产品问题反馈 Product Feedback

»» 项目编号-Project NO. : UN20177

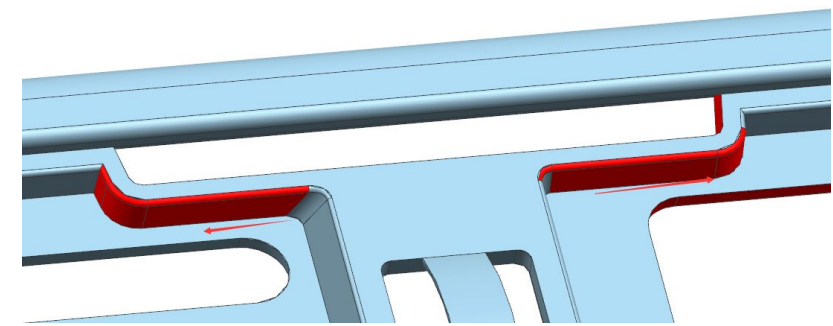
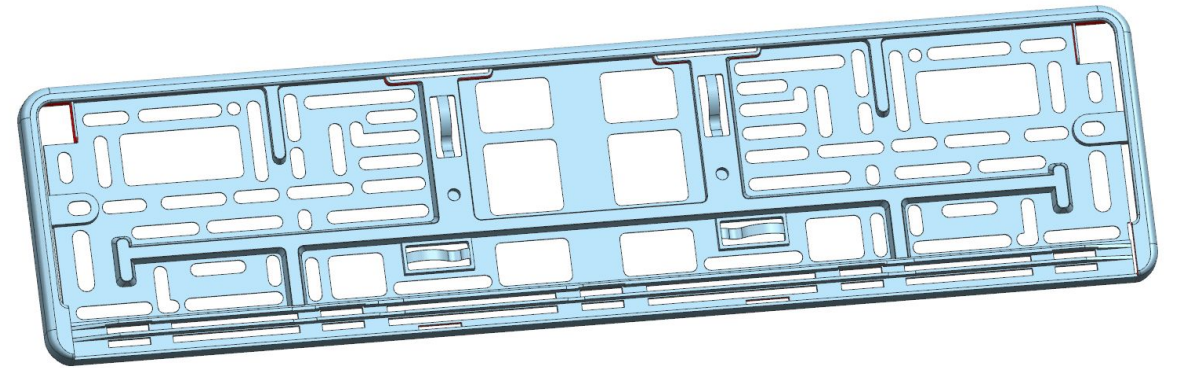
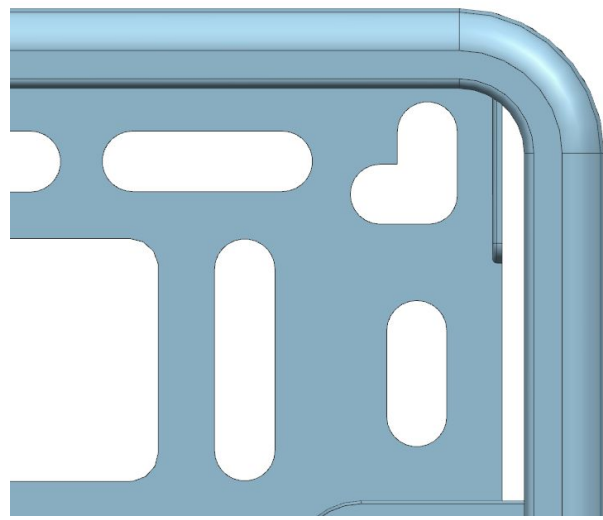
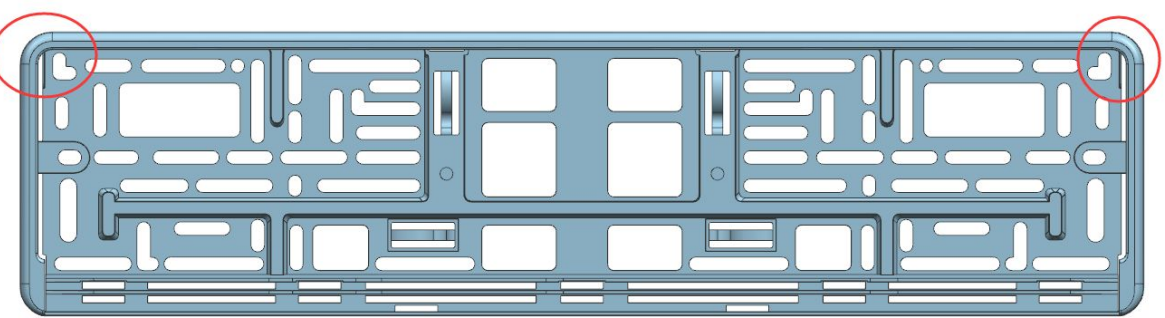
如图, 孔每边加大15mm
Can we make Hole length longer by 15mm on both sides ?

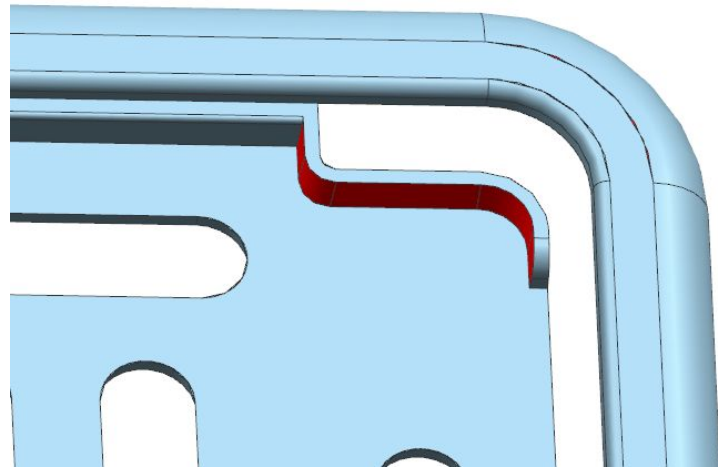
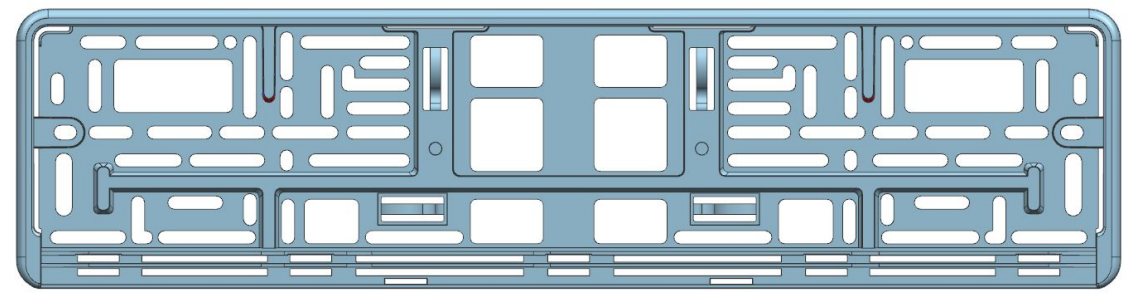
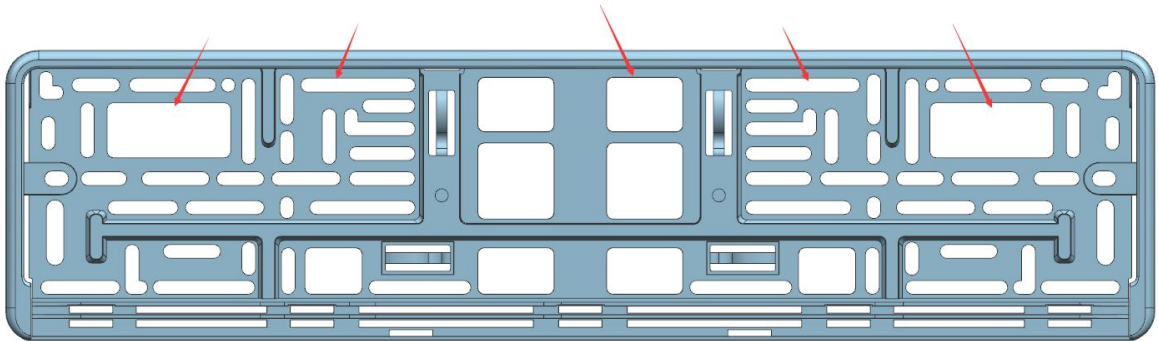
如图，筋位改变
Can we make change on rib design

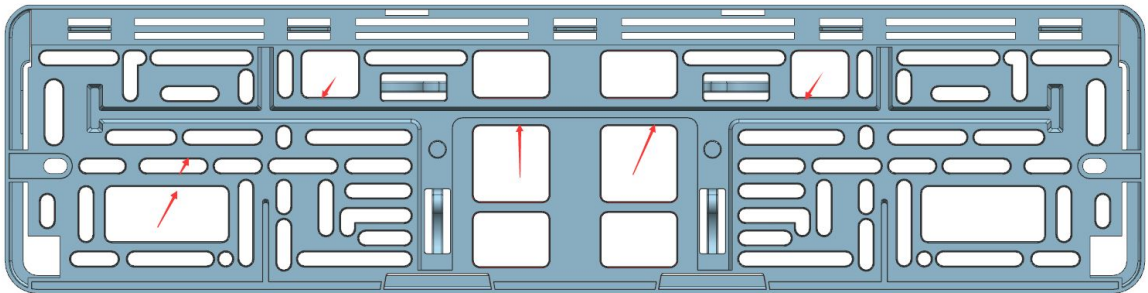
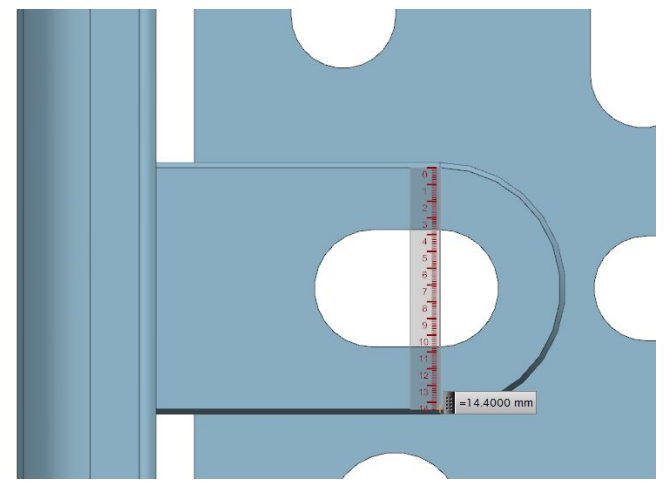
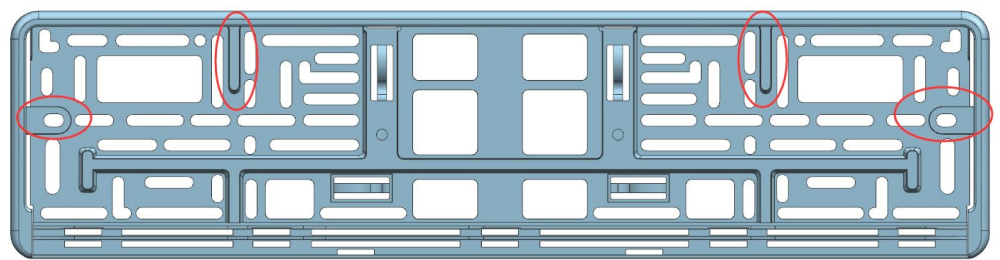
如图，类似的孔，斜度加大到10度
Can we make hole angle to 10 degree

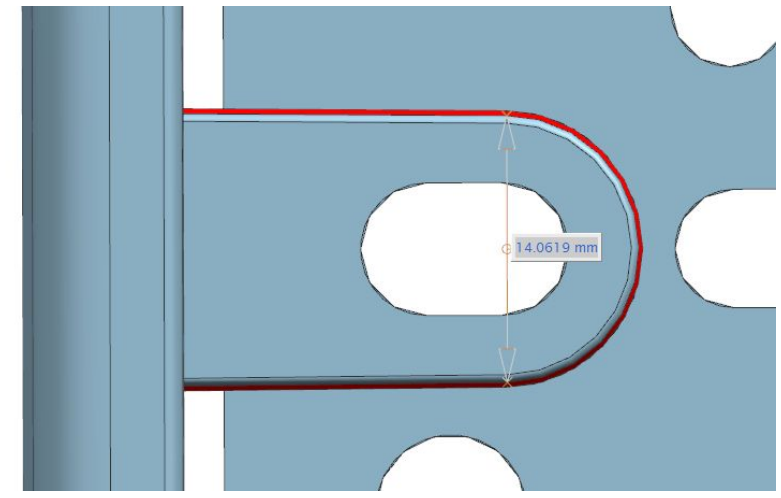
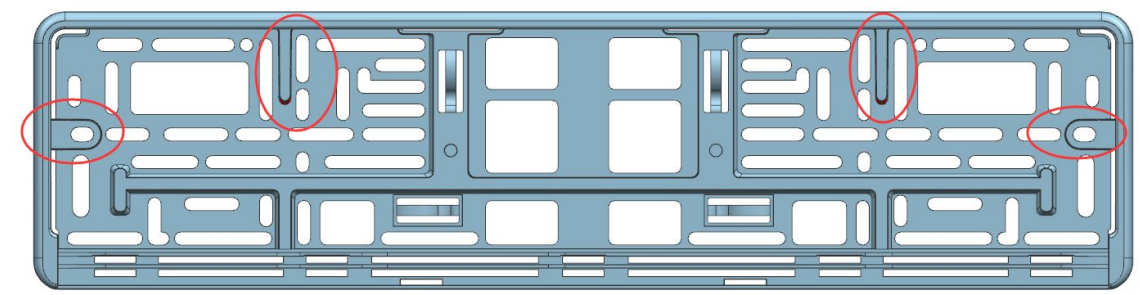
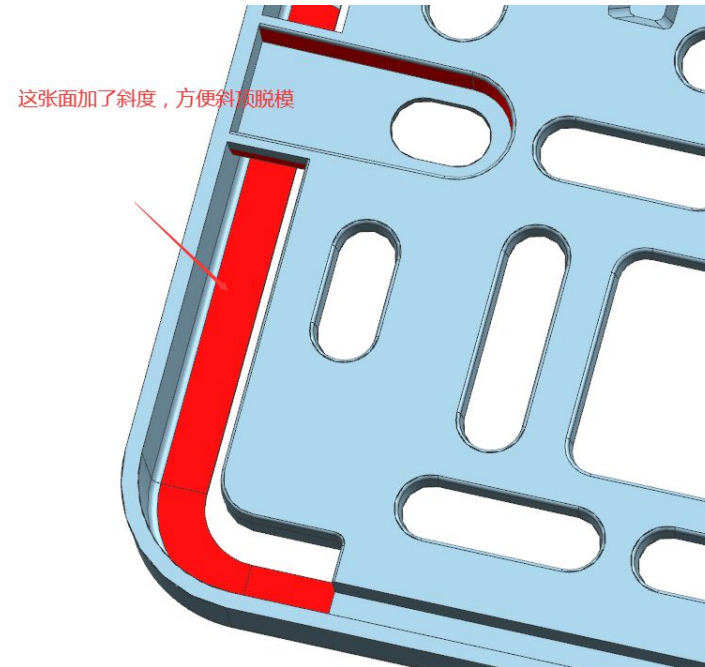
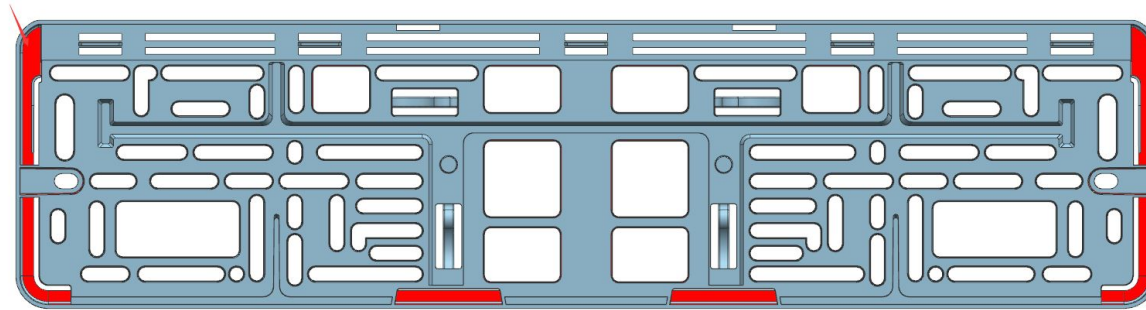
如图4个形状头部缩小单边0.2mm方便脱模
Can we reduce by 0.2mm on every side, it will be easier for mold ejection
